AQUIND INTERCONNECTOR

Statement of Common Ground Between
AQUIND Limited and the Marine Management
Organisation

Document Ref: 7.5.16

DATE: 15 FEBRUARY 2021

Figure 1. Benthic baseline PSA results based on Folk Classification. No grabs returned from sampling stations 8 and 22. (taken from Figure 9, Benthic Ecology Survey Report)

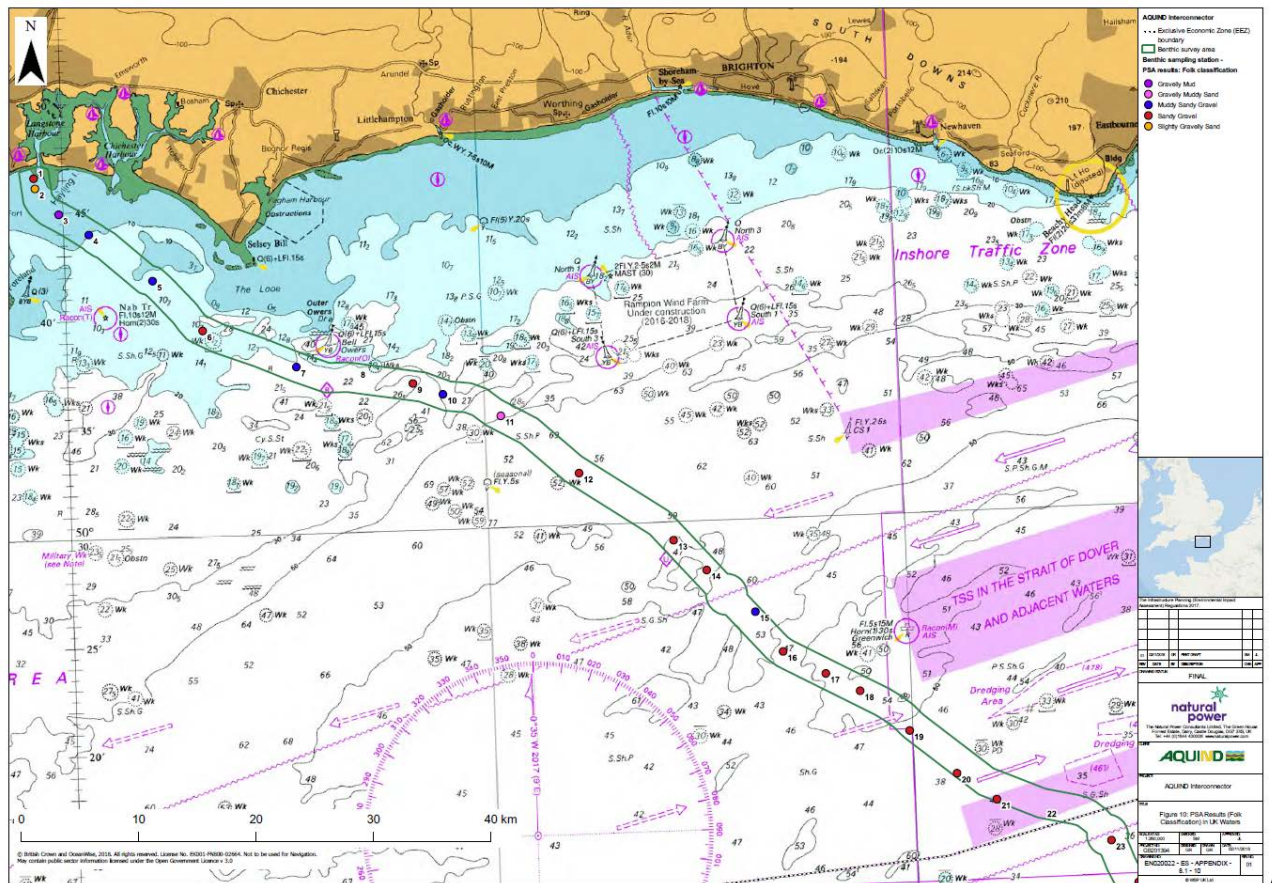
Coarse sediment has a limited affinity for sorption of chemical contaminants and therefore sediment contamination would not be expected to pose a significant risk in the offshore areas of the route given the PSD results."
